Figure 15.6-11—SGTR ~~Event~~ Radiological Case - Reactor Power

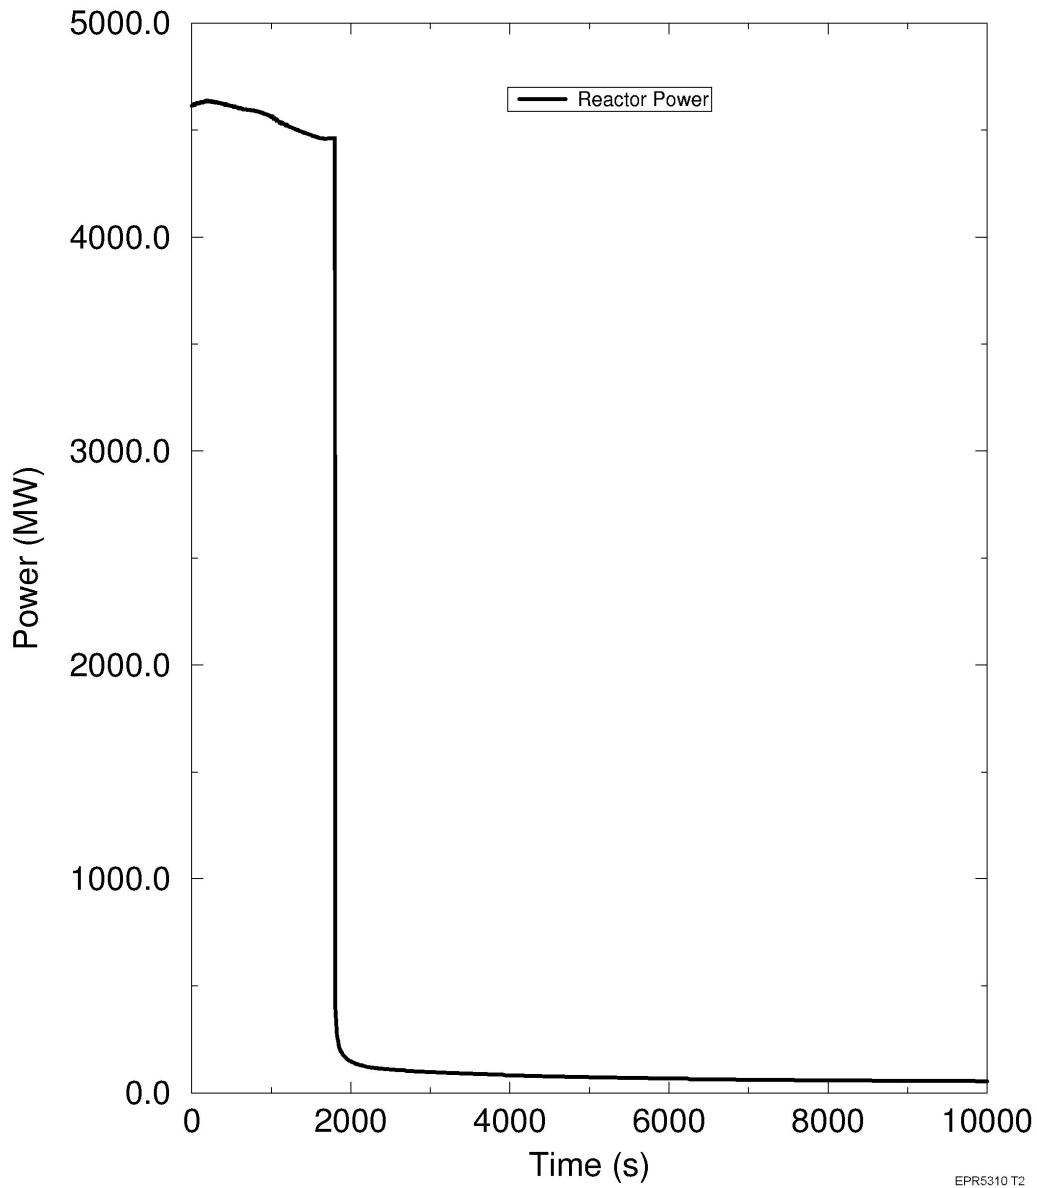
15.06.03-3

Figure 15.6-15—SGTR ~~Event~~ Radiological Case - Total MHSI Flow Rate

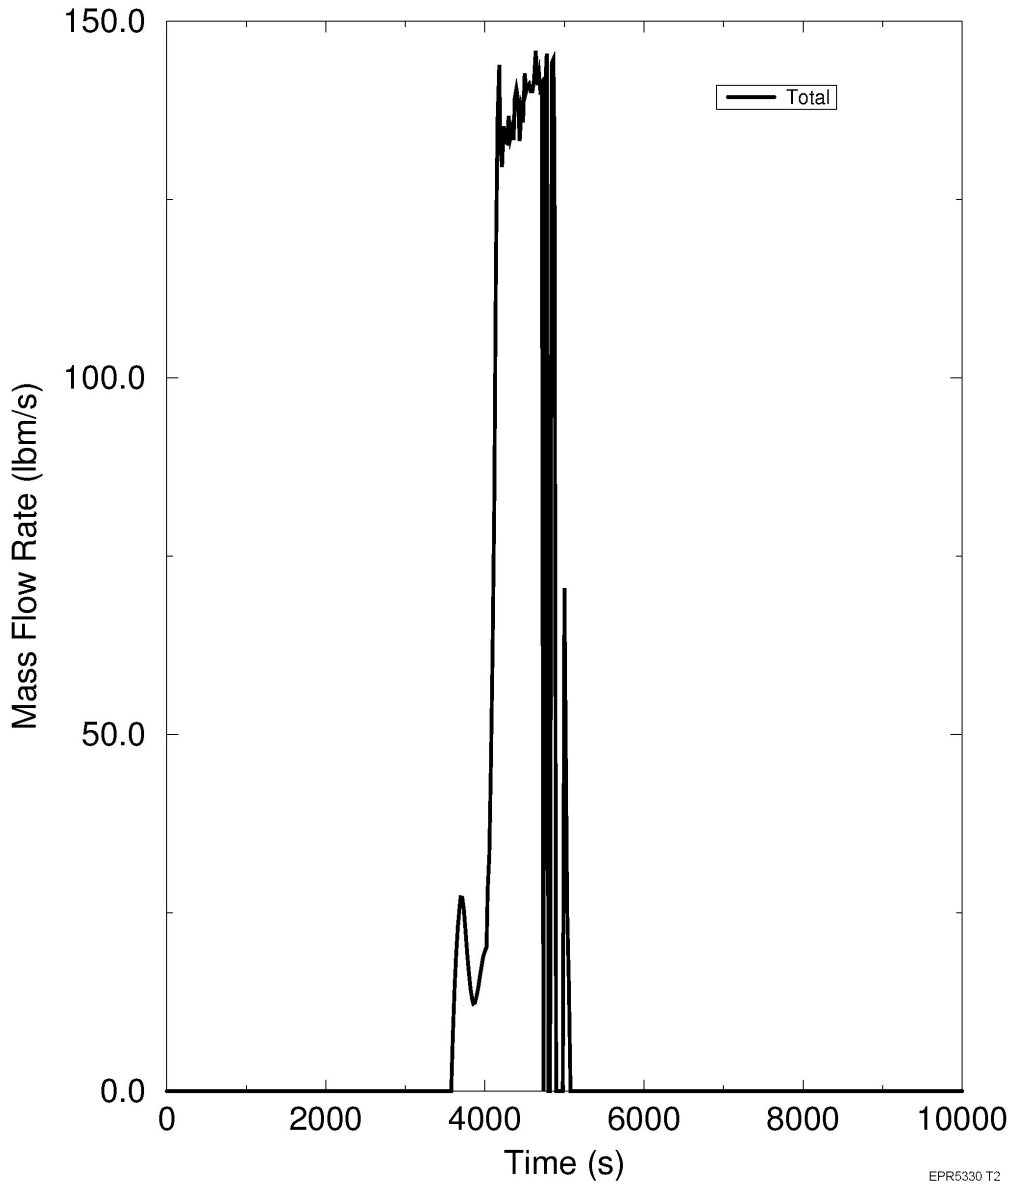
15.06.03-3

Figure 15.6-20—SGTR ~~Event~~ Radiological Case - Pressurizer Level

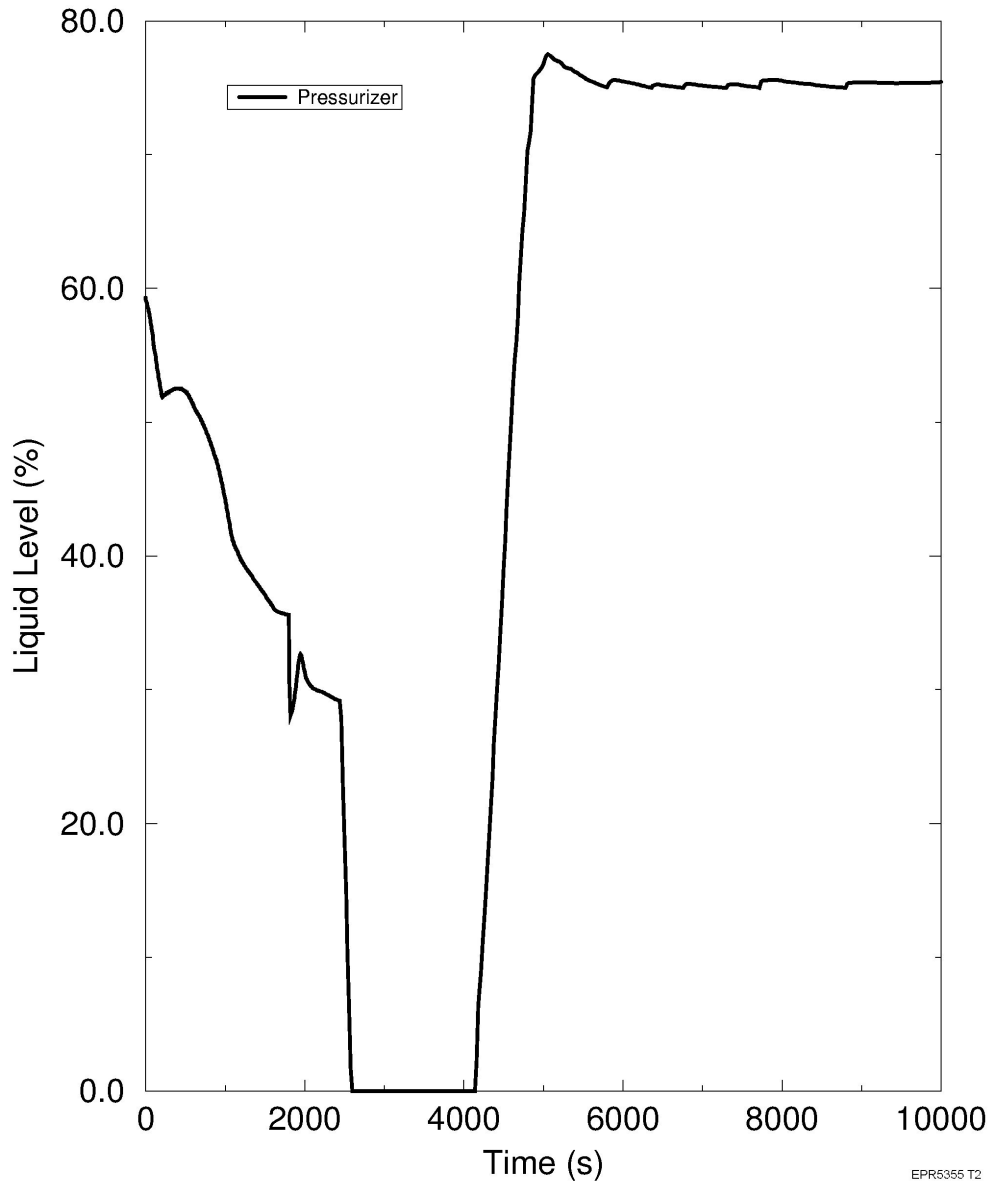
15.06.03-3

Figure 15.6-22—SGTR ~~Event~~ Radiological Case - Affected SG Liquid Volume

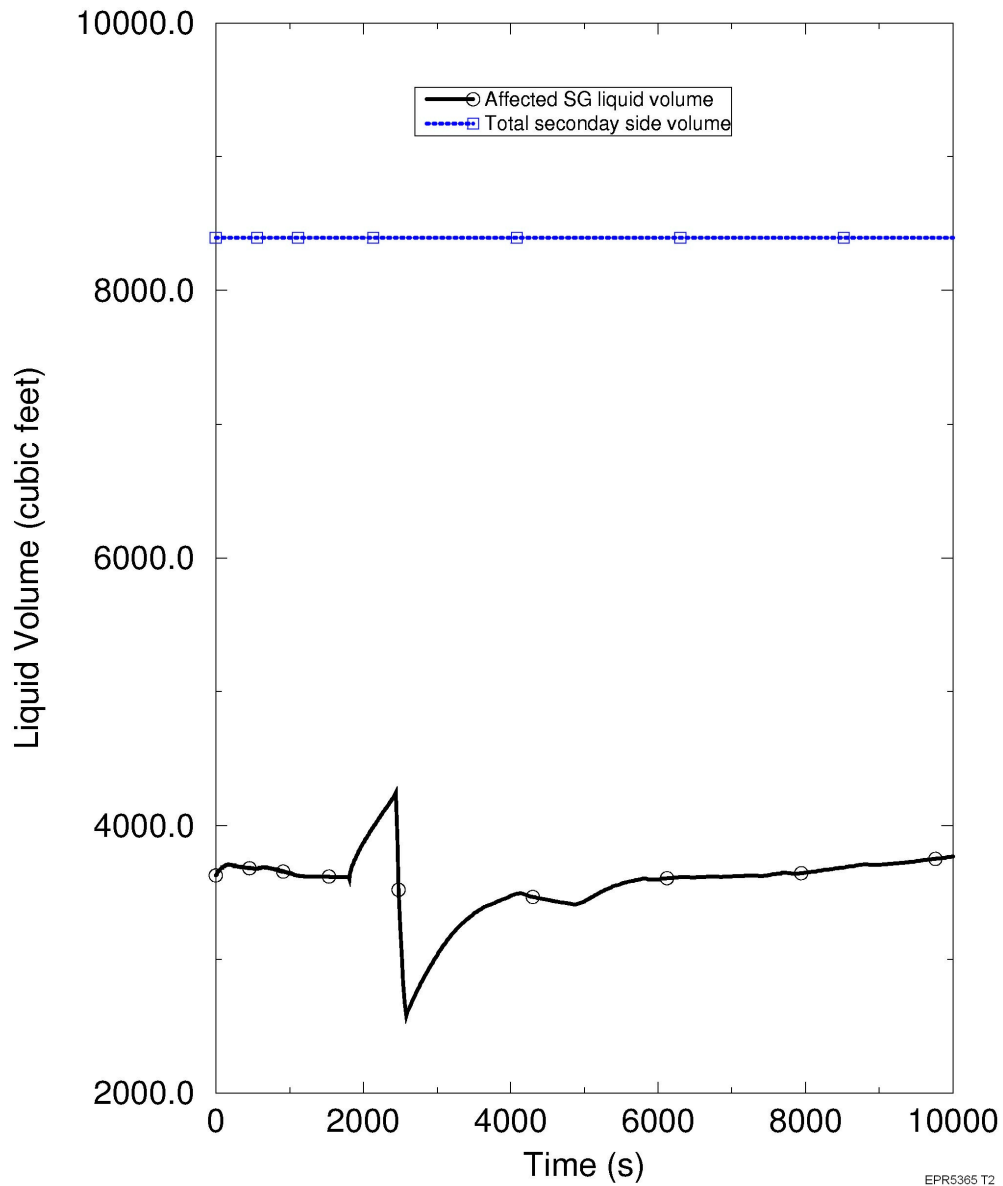
15.06.03-3
